**ALERT SERVICE BULLETIN**

**SUBJECT: REVISION "C" TO ALERT SERVICE BULLETIN ASB 206-07-115:  
POWER TURBINE RPM (N2) STEADY STATE OPERATION  
AVOIDANCE, INTRODUCTION OF.**

NO. 206- 07-115

REV C

Figure 1- Typical 206B Instrument Panel Layout  
 (May vary depending on model and serial number applicability)

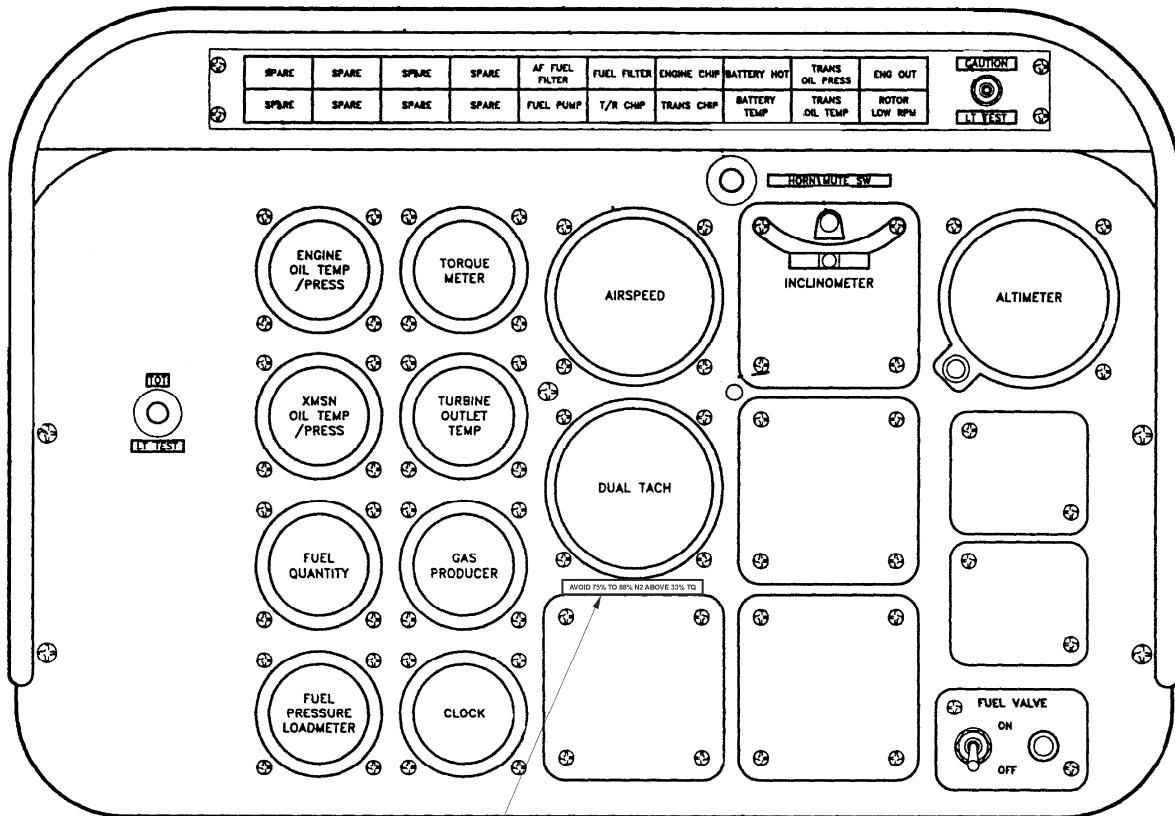
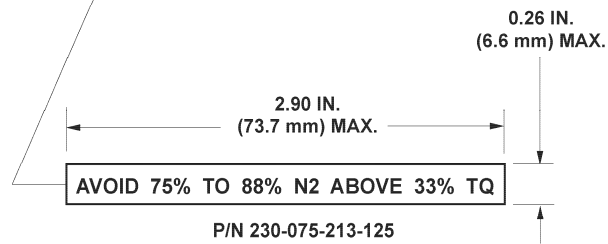
Revision "C" to this bulletin introduces a new decal removing the "60 SEC MAX" wording.

1. Remove previously installed 230-075-213-121 decal and discard.
2. Install 230-075-213-125 decal on the instrument panel as shown in Figure 1 below the NR/N2 dual tachometer. Sealer C-349 shall be applied over the installed decal.

1. One decal is provided with this bulletin.
2. The decal may be locally manufactured using lettering of white color (No. 17875) on black background color (No. 17038). Characters to be 10 point Spartan blackfont. Color per FED STD 595. The text for the decal is detailed in Figure 1 and should be in capital letters. It is permissible to use existing decal provided the "60 SEC MAX" wording is cut and removed.
